Alert Service Bulletin No. 074 Rev. A

Turbocharger Center Housing Inspection

1. This page transmits the revision of Alert Service Bulletin 074 Rev. New to Alert Service Bulletin 074 Rev. A, dated December 26/17.
 - A. Revision ASB 074 Rev. New, dated December 05/17
 - B. Revision ASB 074 Rev. A, dated December 26/17
2. FAA approval has been obtained on technical data in this publication that affects type design.
3. Changes are shown by a change bar in the left or right margin coinciding with the change on the affected page.
4. This revision is issued to change the following:
 - A. Table 1A thru 1C
 - (1) Included lock plate part numbers to all kits
 - B. Table 2
 - (1) Updated with seven (7) additional center housing serial numbers.

Turbocharger Center Housing Oil Drain (lower) Flange
Figures 3 & 4

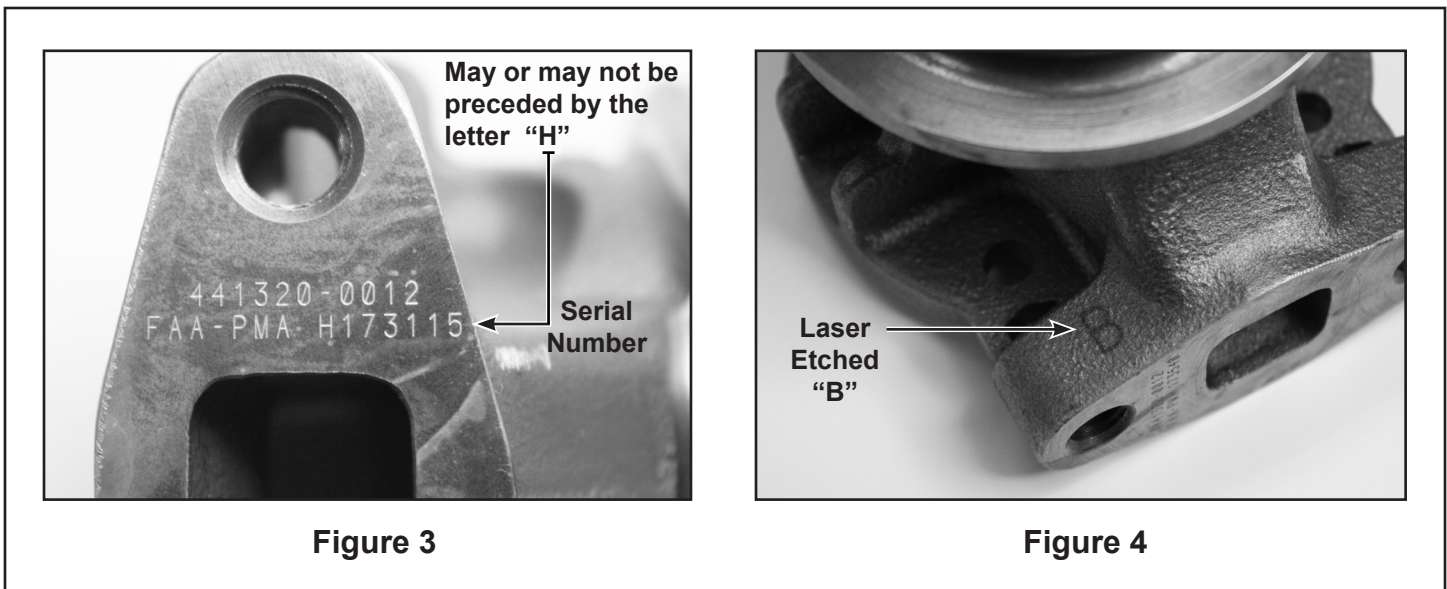
- (3) If the turbocharger was serviced between 10 May, 2017 and the effective date of this ASB, and effectivity cannot be established from the maintenance records, utilize the applicable aircraft maintenance manual to gain access to and remove the turbocharger center housing oil drain line from (lower) flange. Inspect turbocharger center housing serial number against affected serial numbers found in Table 2 of this ASB. (See Figure 3 for serial number illustration)

NOTE: Serial numbers found in Table 2 may or may not be preceded by the letter “H” as shown in Figure 3.

- (1) Affected turbochargers and/or center housings
 - (a) Replace turbocharger center housing with one not associated with this ASB.
 - 1 Replacement center housing may be new or factory reworked.
 - 2 Factory reworked center housings will be identified by a laser etched “B” located on the side of the oil drain flange (See Figure 4).
